RFQ NUMBER
DEFK7002

July 24, 2006
ADDENDUM NO. 1
DEFK7002

RE: Regional Training Institute
Interior Remediation
Camp Dawson
Kingwood, West Virginia
West Virginia Army National Guard
ZMM Project No. 9735

RTI - SKETCH A-1

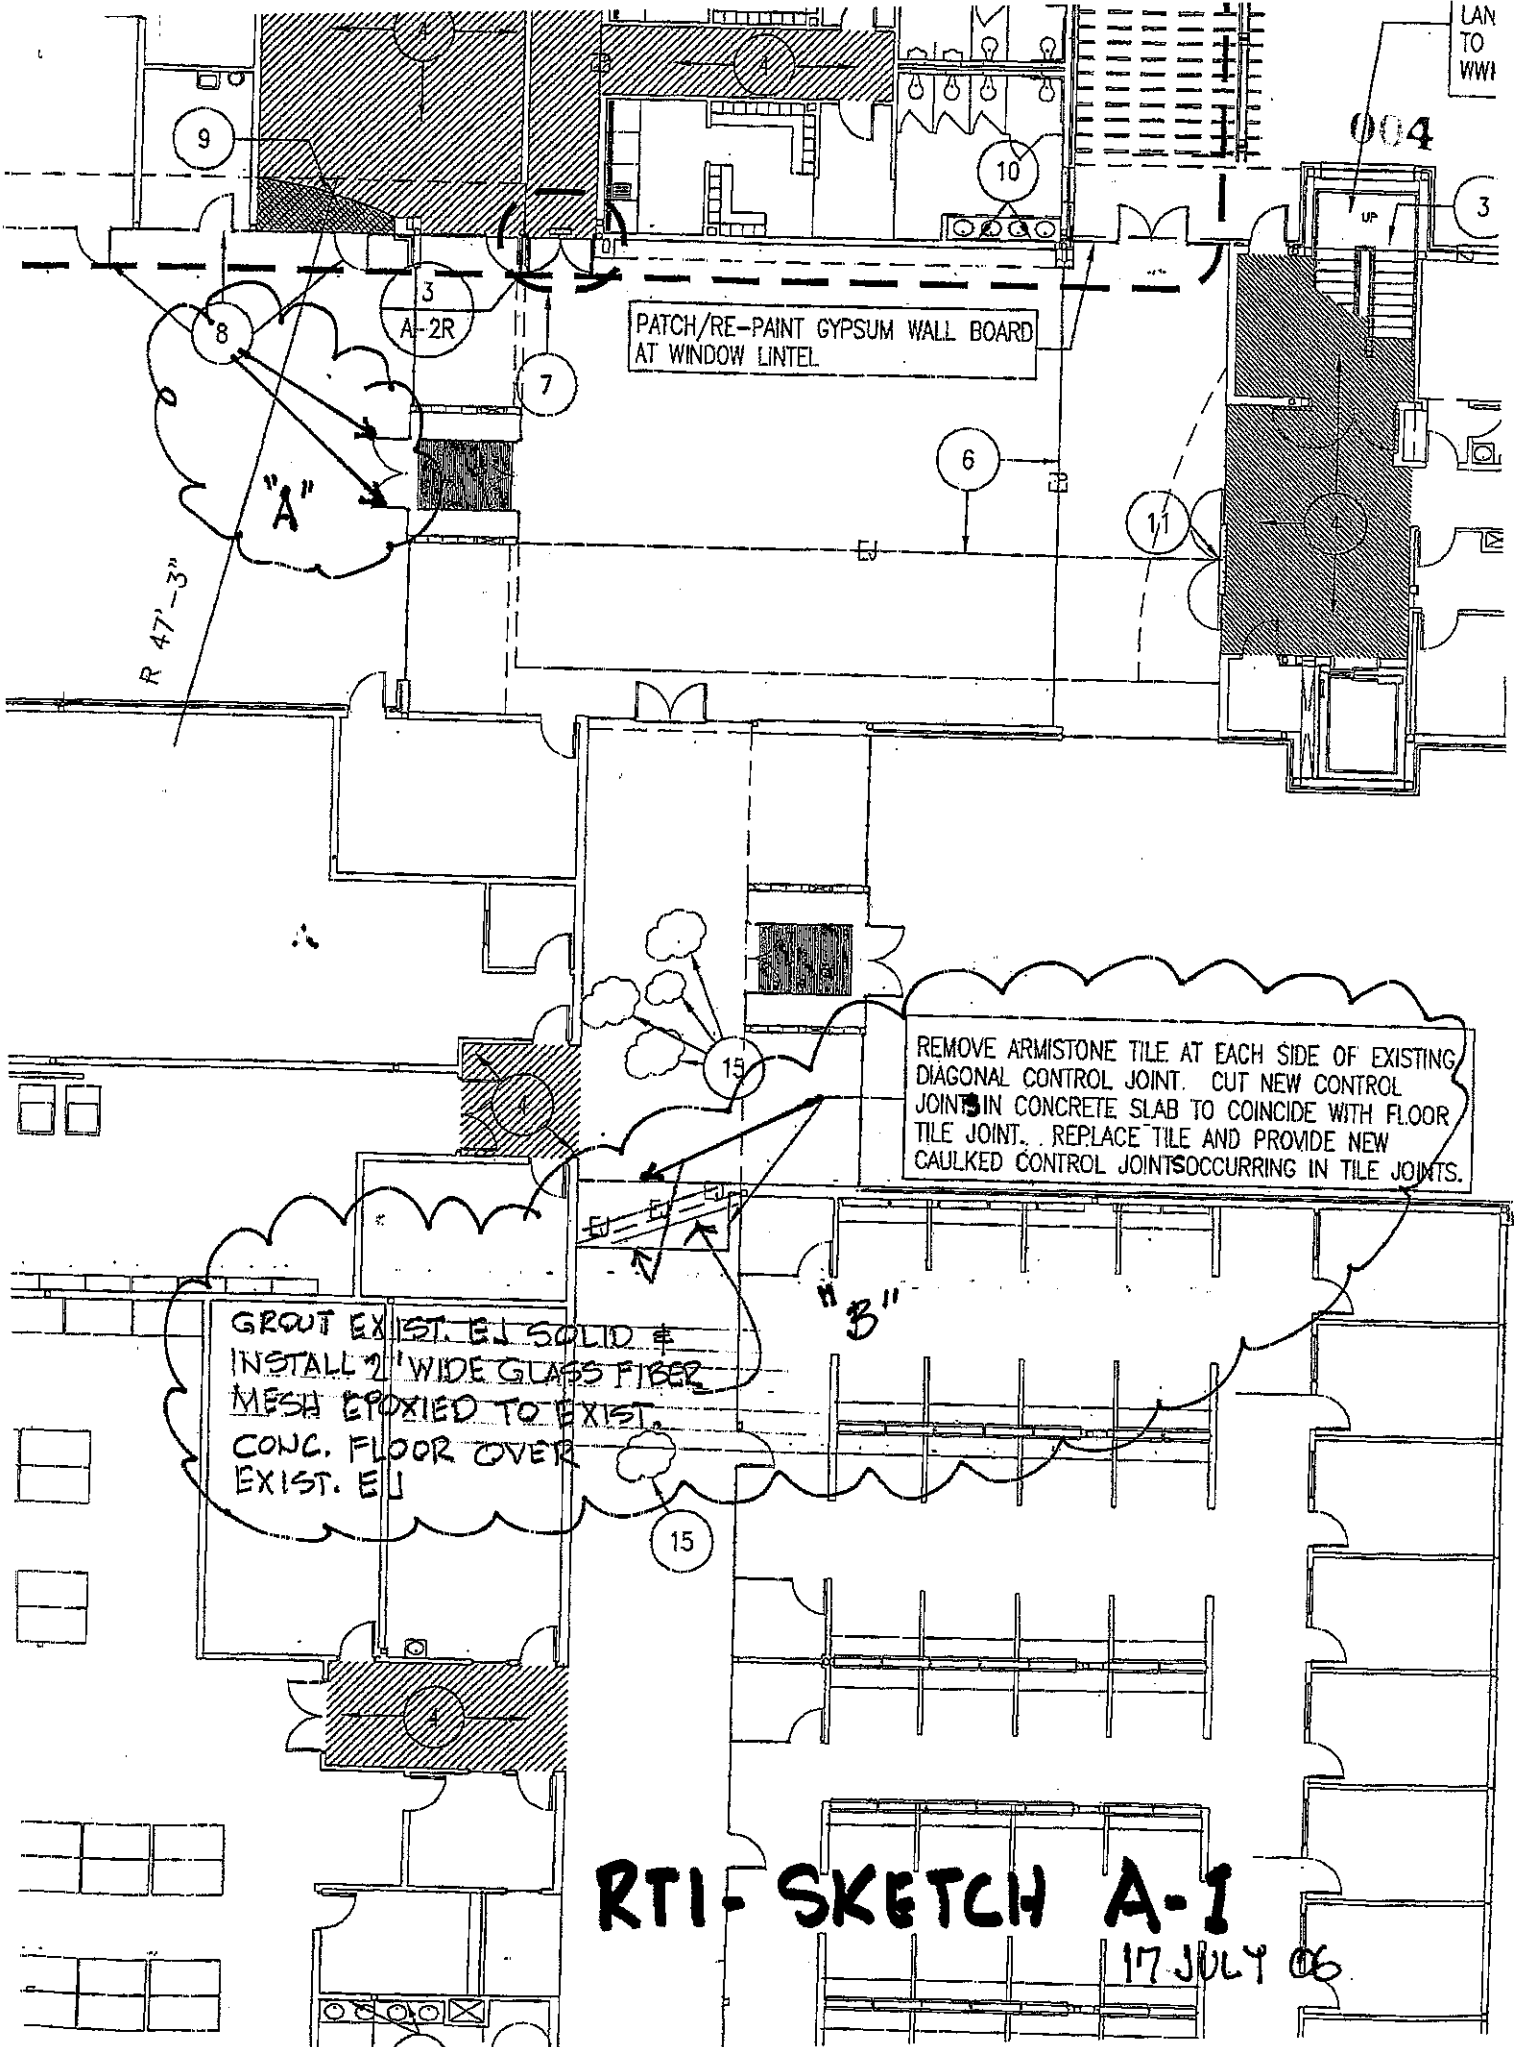
1. Refer Keyed Note "8" referencing painted doors. Include door frames to be painted.
2. Refer to attached sketch A-1 dated July 17, 2006 Note "A" for added doors and frames to be painted.
3. Refer to attached sketch A-1 dated July 17, 2006 Note "B" for additional expansion joint repair work.

REMOVE ARMISTONE TILE AT EACH SIDE OF EXISTING DIAGONAL CONTROL JOINT. CUT NEW CONTROL JOINTS IN CONCRETE SLAB TO COINCIDE WITH FLOOR TILE JOINT. REPLACE TILE AND PROVIDE NEW CAULKED CONTROL JOINTS OCCURRING IN TILE JOINTS.

RTI-SKETCH A-2 17 JULY 06

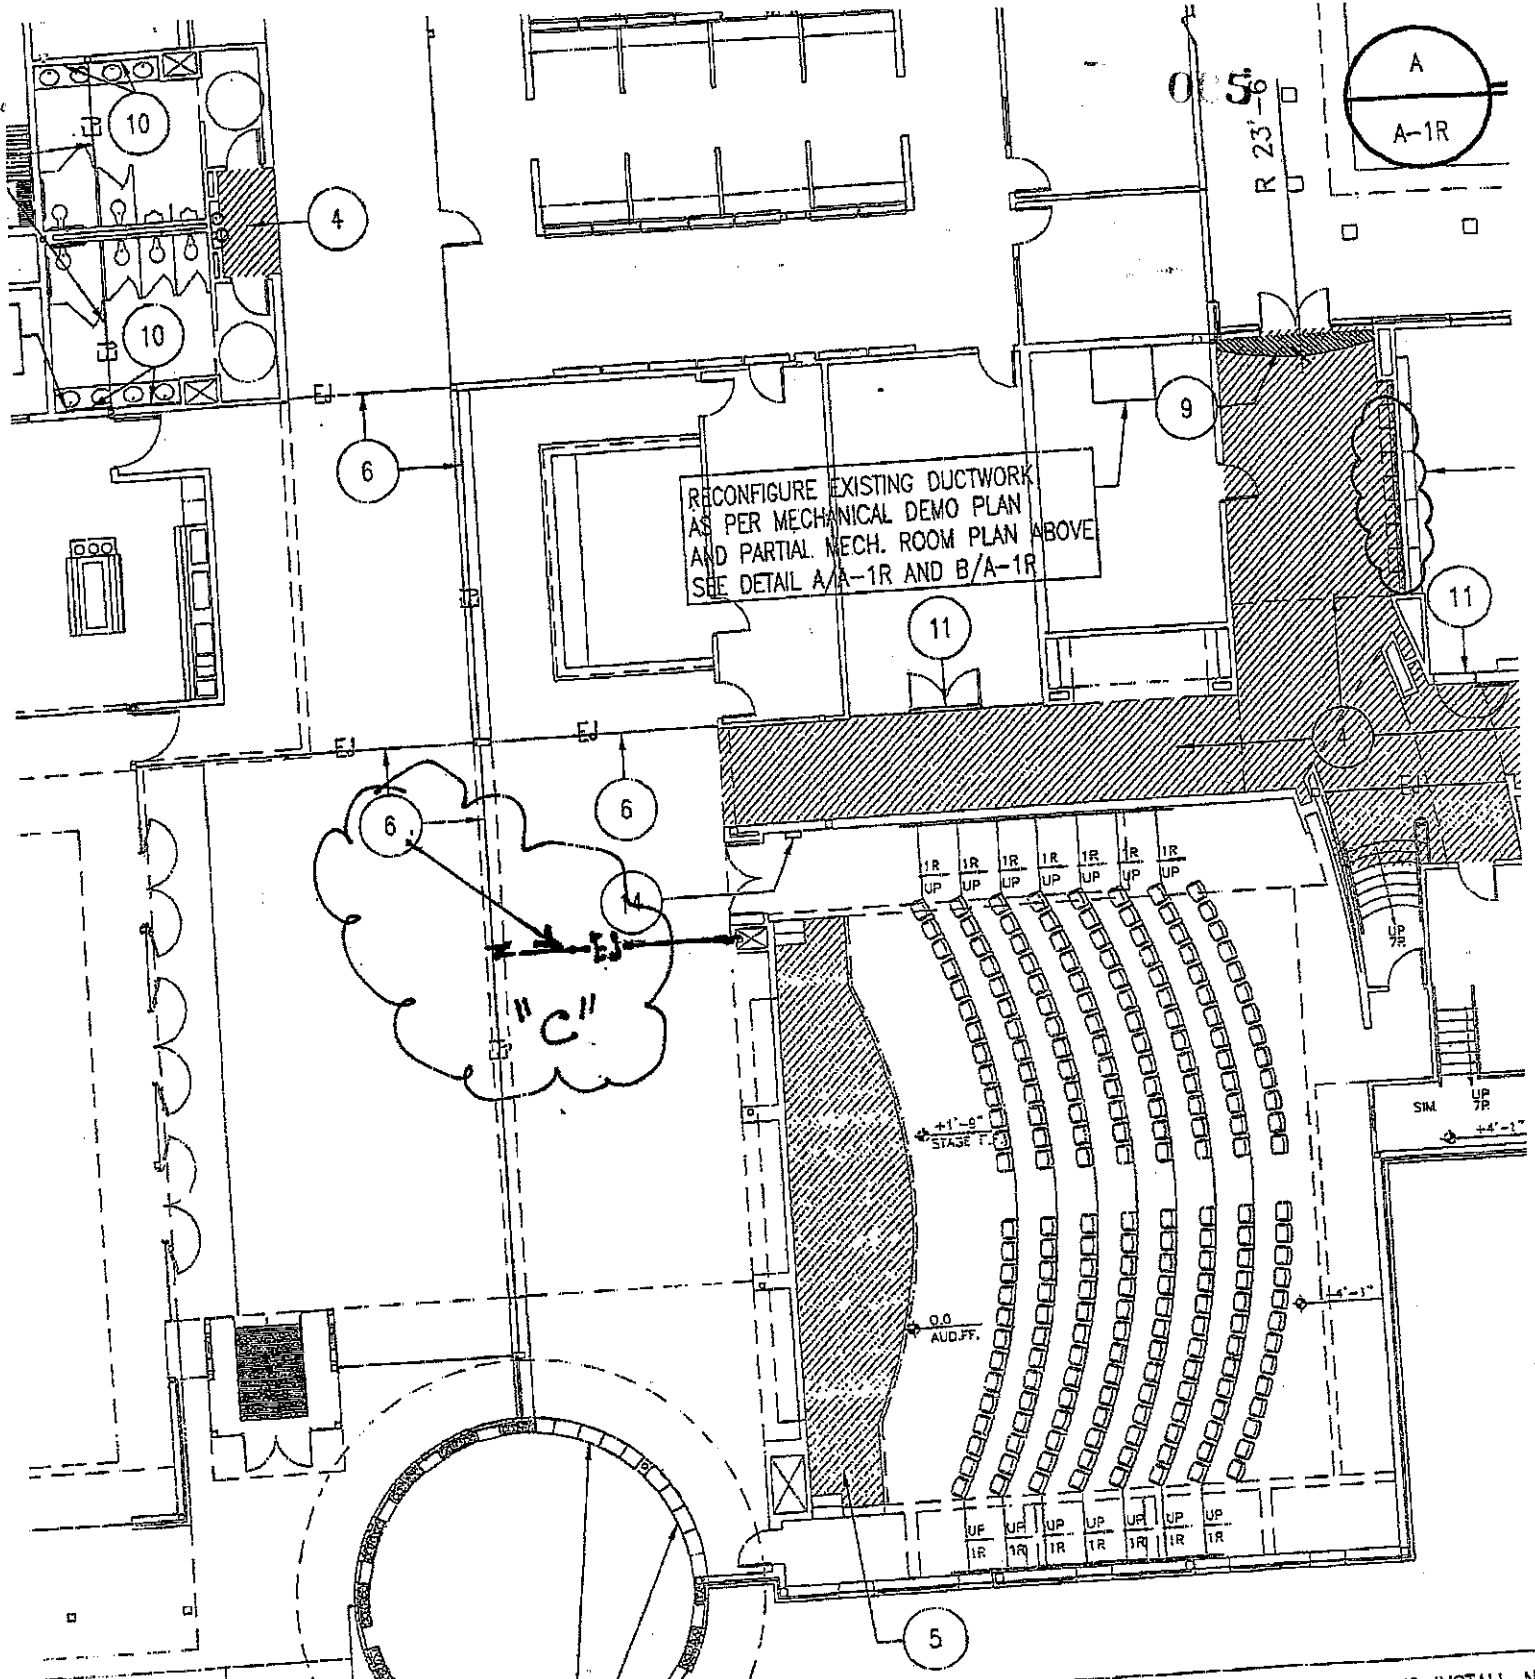
4. Refer to keyed note "10" referencing relocated mirrors. Top of mirrors shall be at 6'-4" above the floor.
5. Refer to attached sketch A-2 dated July 17, 2006 Note "C" for additional expansion joint to be re-caulked.
6. Replace round poly-carbonate lenses in 27 ceiling-mounted light fixtures in the pool area. This work shall be included in Alternate Bid No. 1.

GROUT EXIST. EJ SOLID & INSTALL 2" WIDE GLASS FIBER MESH EPOXIED TO EXIST. CONC. FLOOR OVER EXIST. EJ
